P23-23
Acme Preliminary Plan

Property Owner: Albrecht Incorporated
 Applicant: Greg Ernst
 Location: Northwest Corner of Wooster Pike and High Point Drive (Parcel #028-19C-20-153)
 Zoning: SPD-1 (Special Planning District) with Underlying C-3 (General Commercial)
 Request: Preliminary Plan approval for a grocery store with a pharmacy drive through

PRELIMINARY
LANDSCAPE DEVELOPMENT PLAN

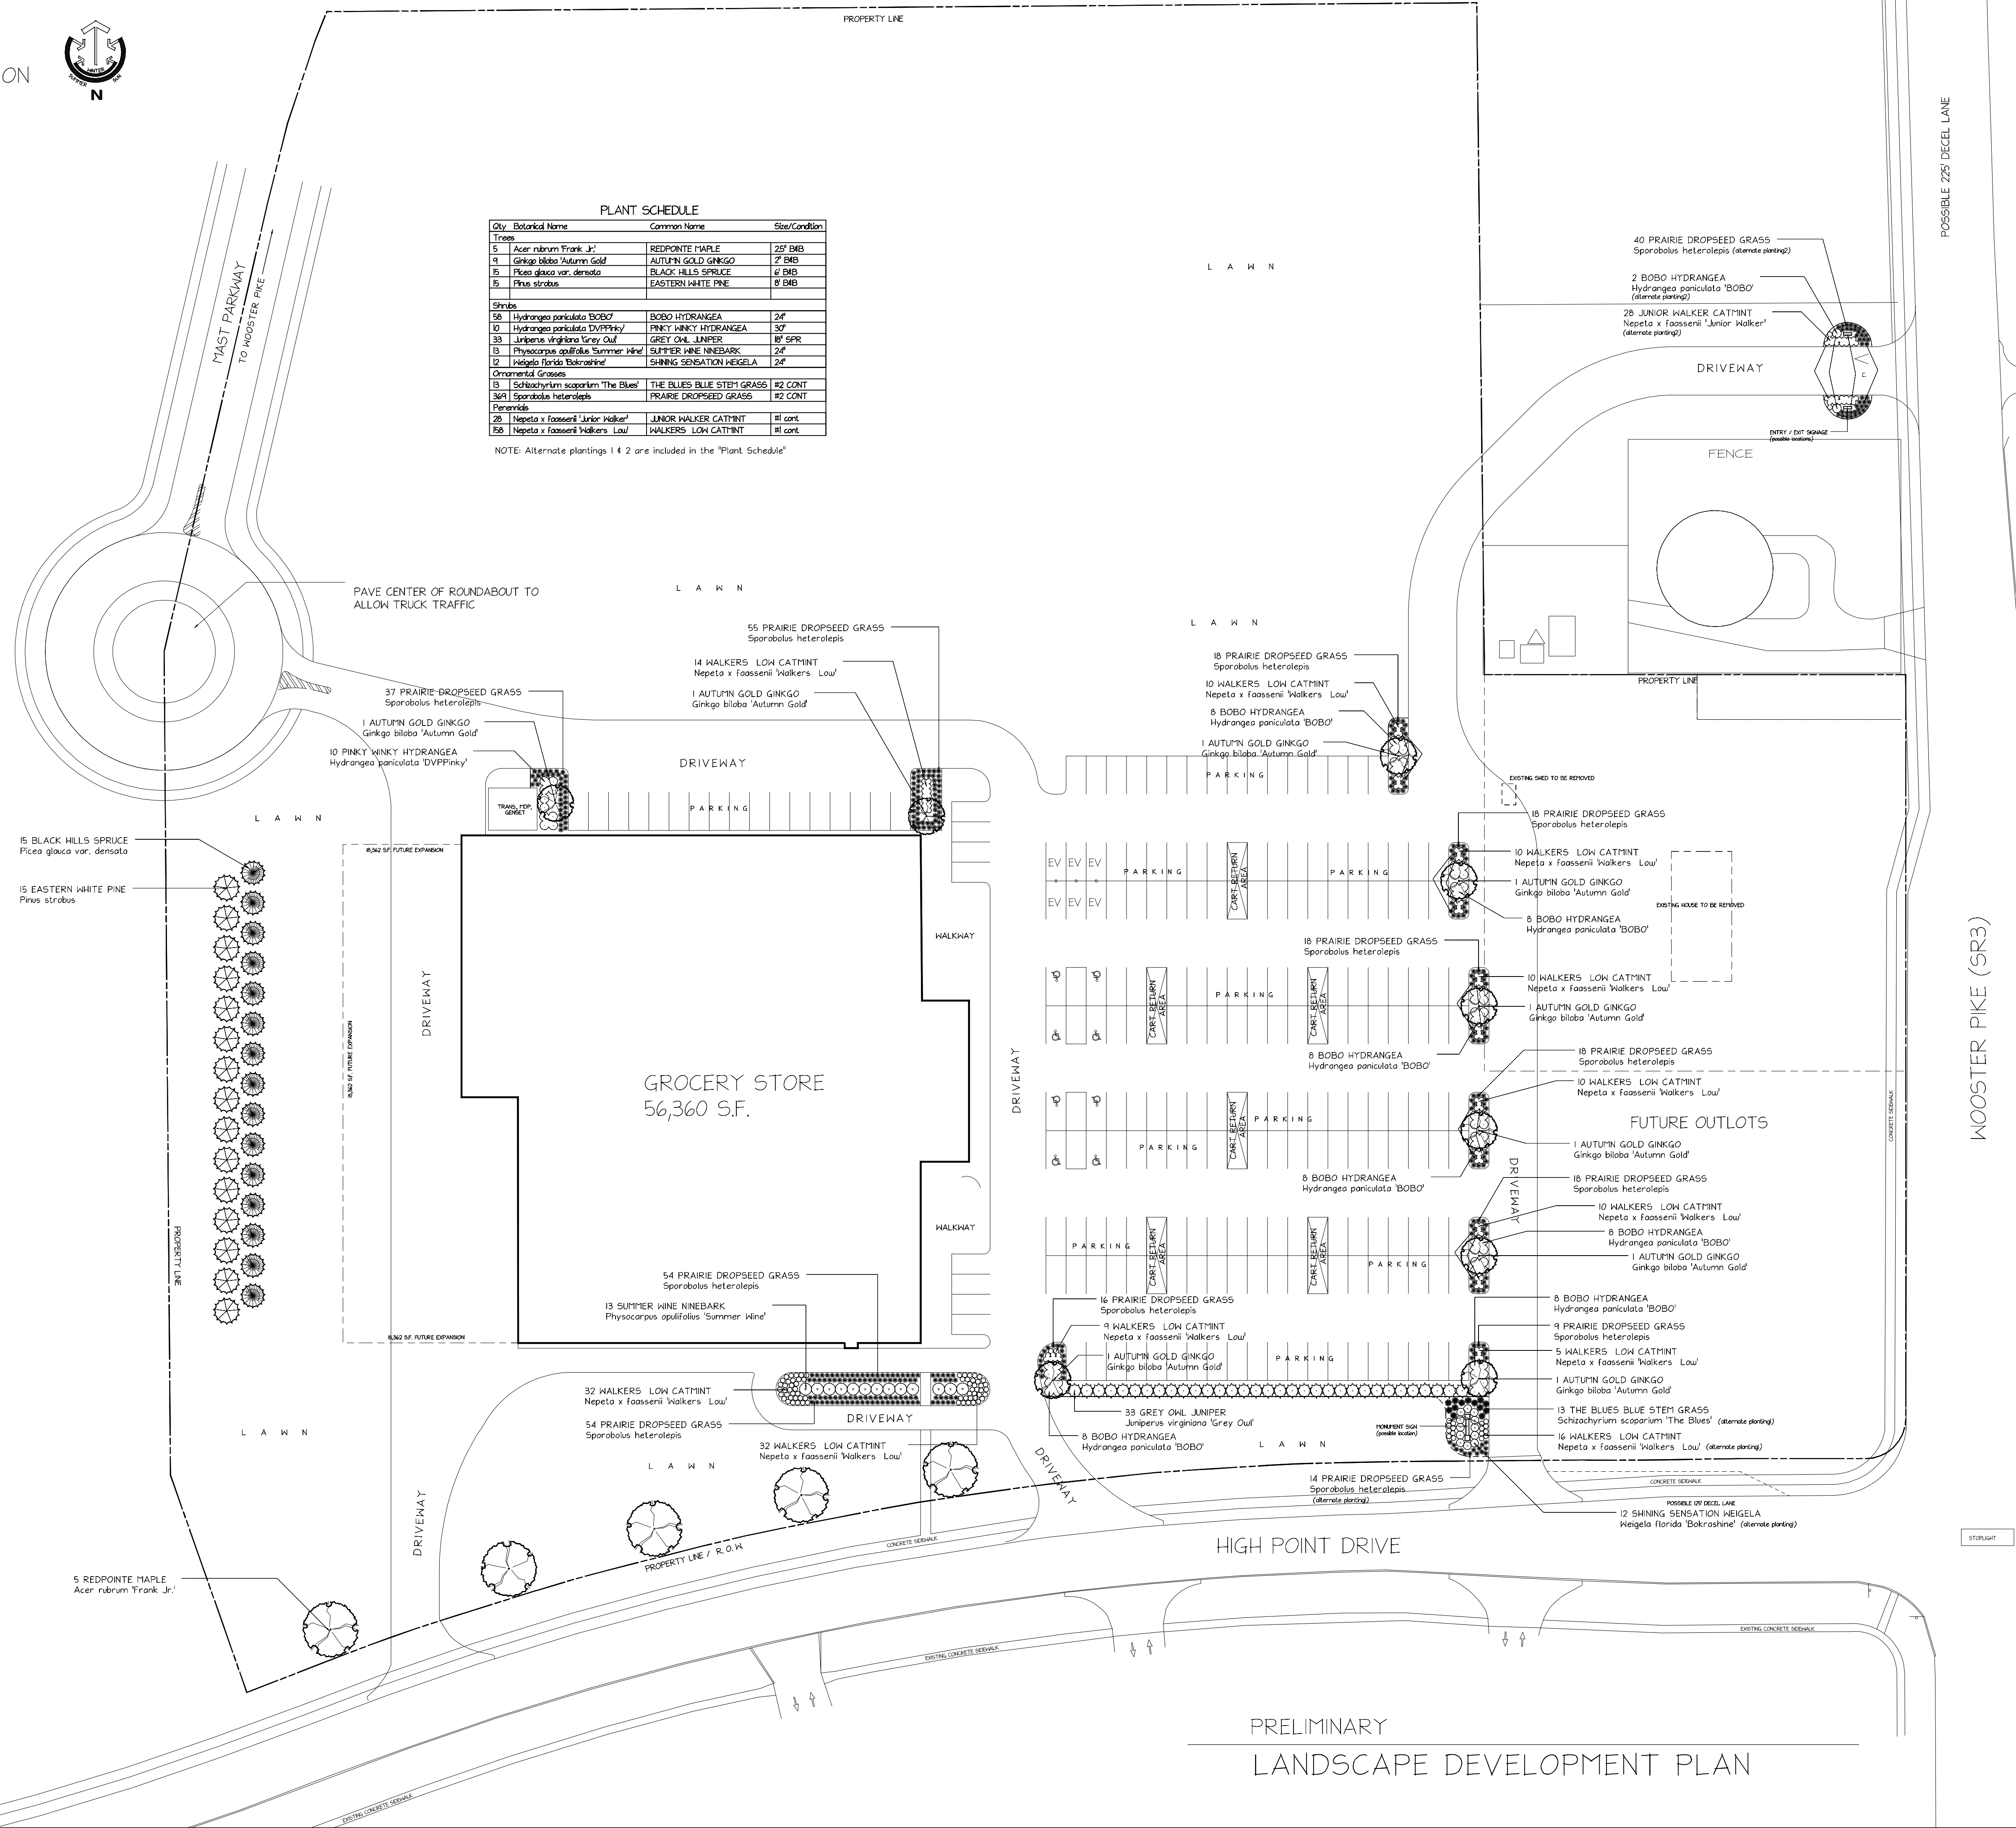
The Landscape Plan shows landscaping islands within the parking lot every 20 spaces, or less. All sheets will need to indicate the islands as landscaped, rather than painted hatches. In addition, landscaping is provided between the parking lot and High Point Drive.

Forestry – The Forestry Department has requested that large canopy street trees be included in the landscaping plan along High Point Drive. Spacing can be determined based on entry/exit drives, signs, etc., but there should be approximately 40 ft. between street trees.

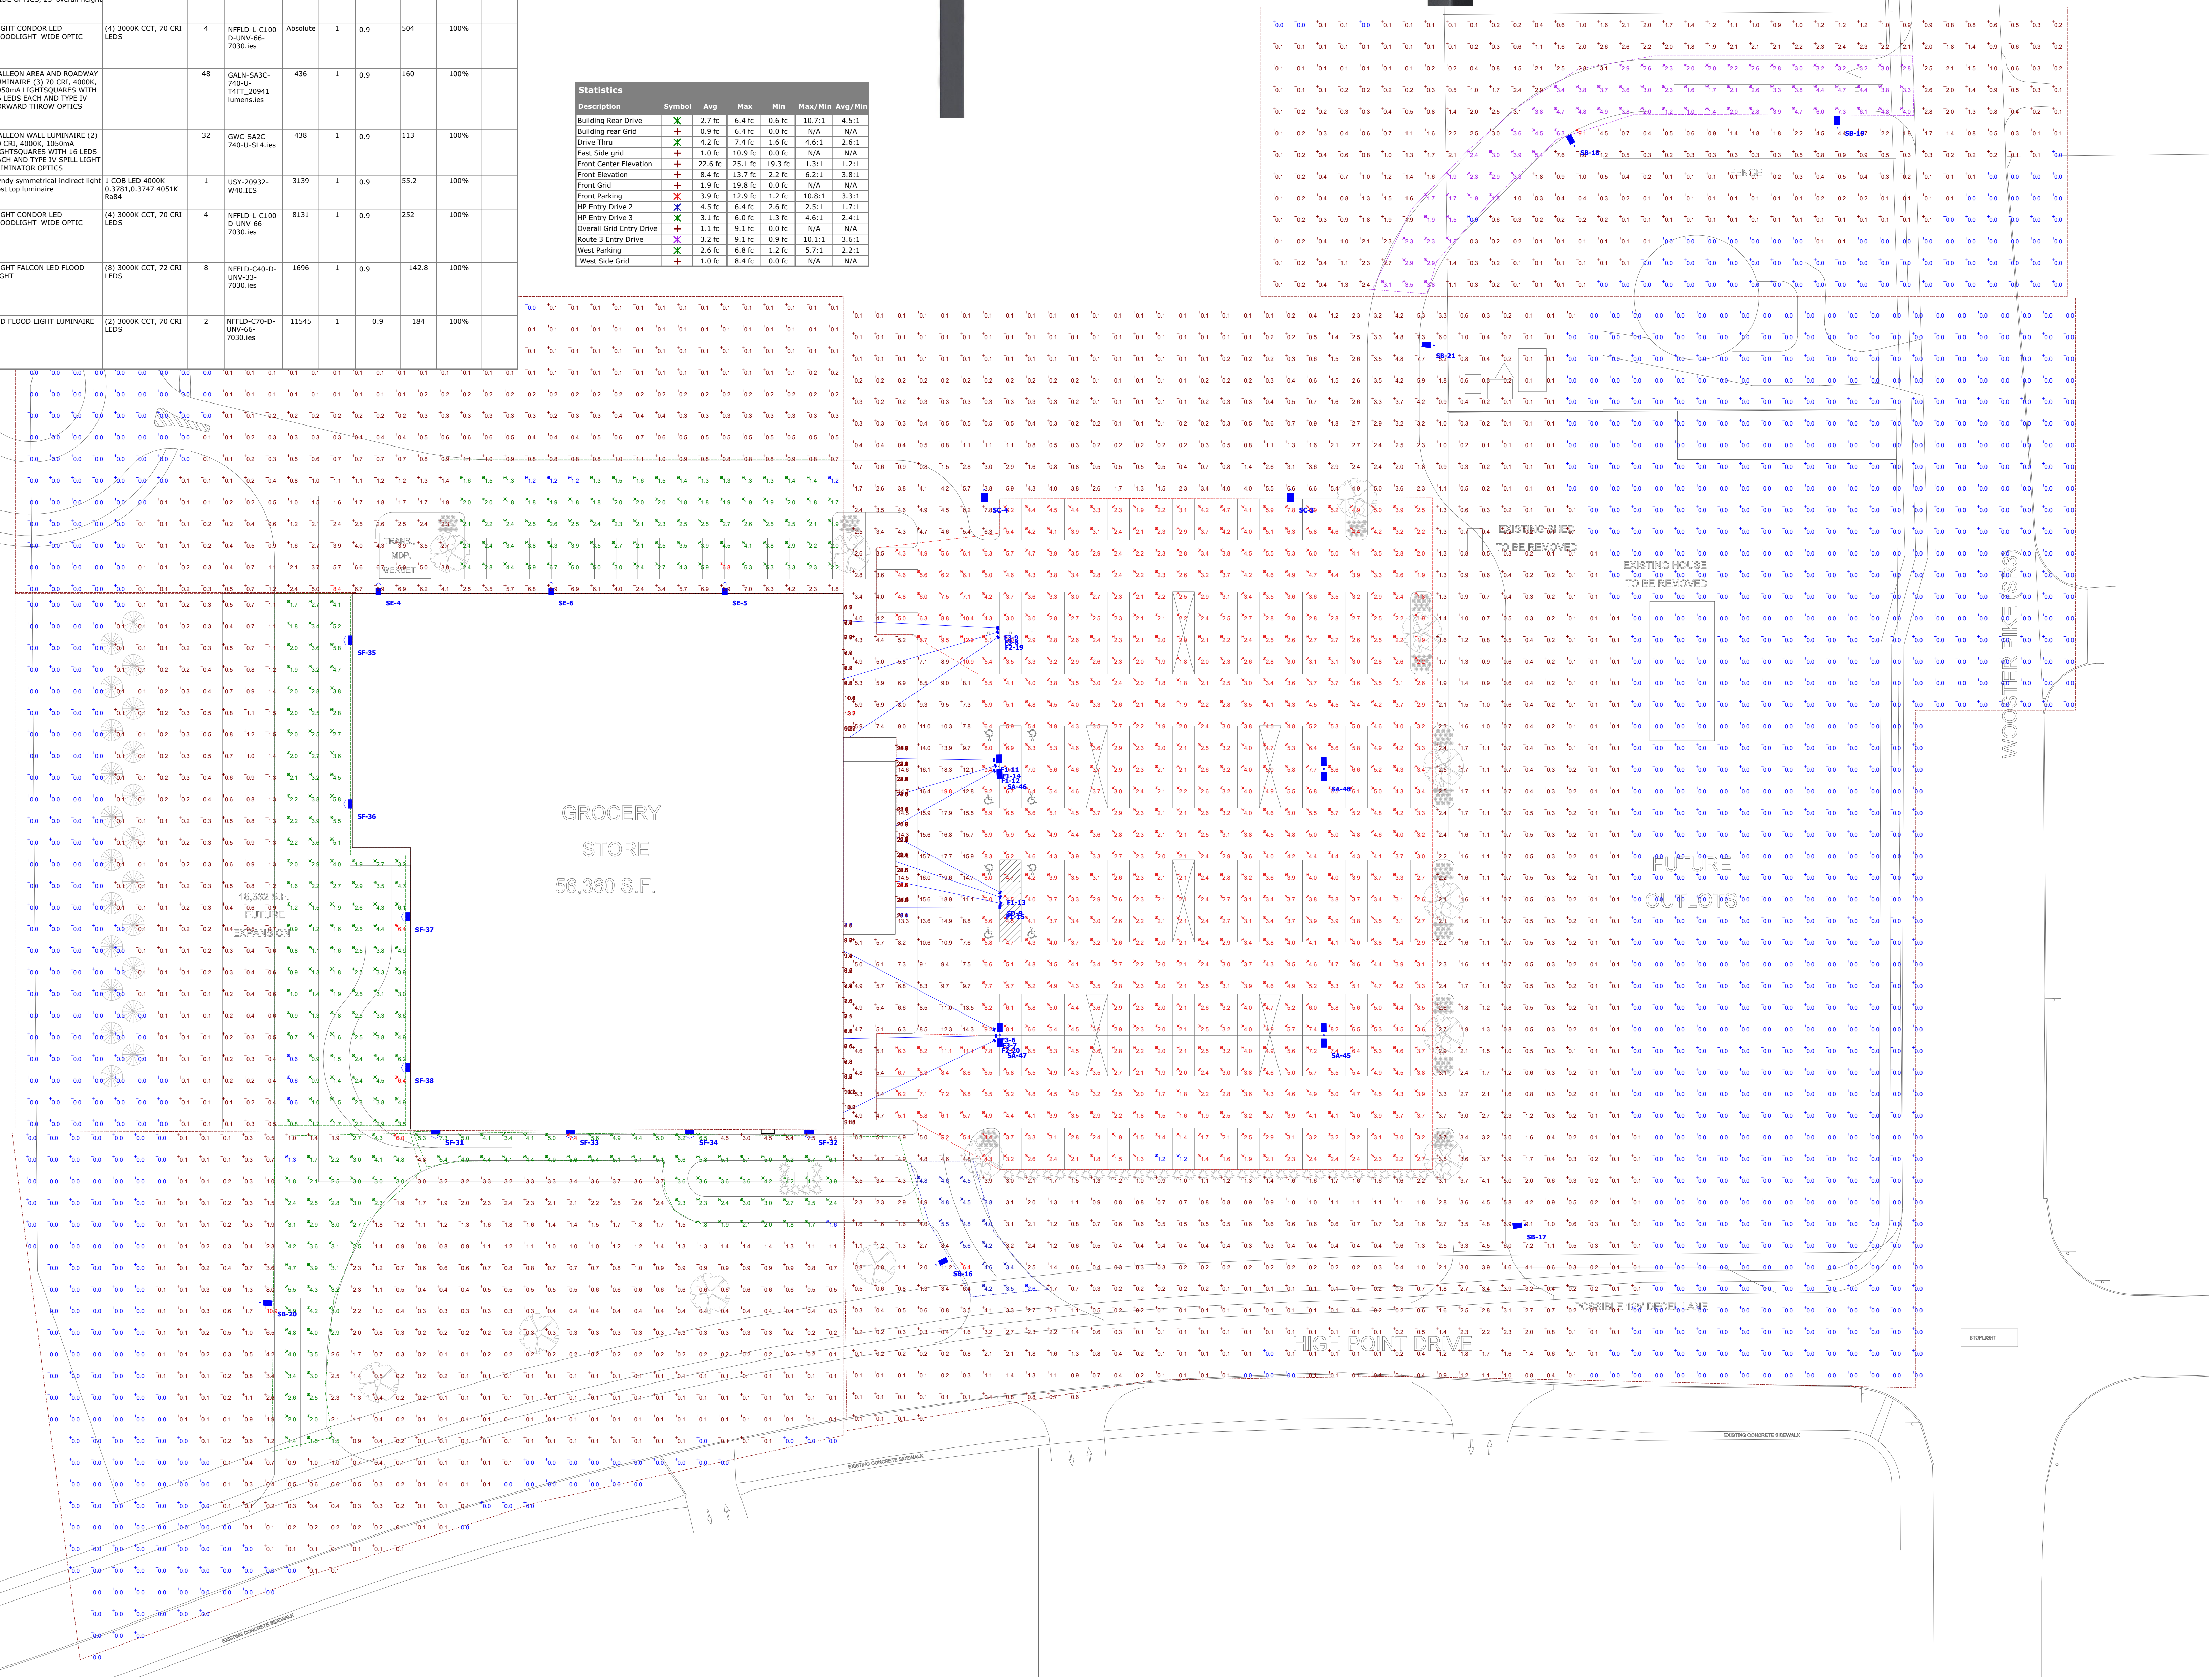
directed at the parking lot is compliant with this requirement, however, light types “F2 & F3” and “SD & F1” are directed at the building face. The lighting of a building in this fashion is not uncommon and is used at the Medina Giant Eagle location.
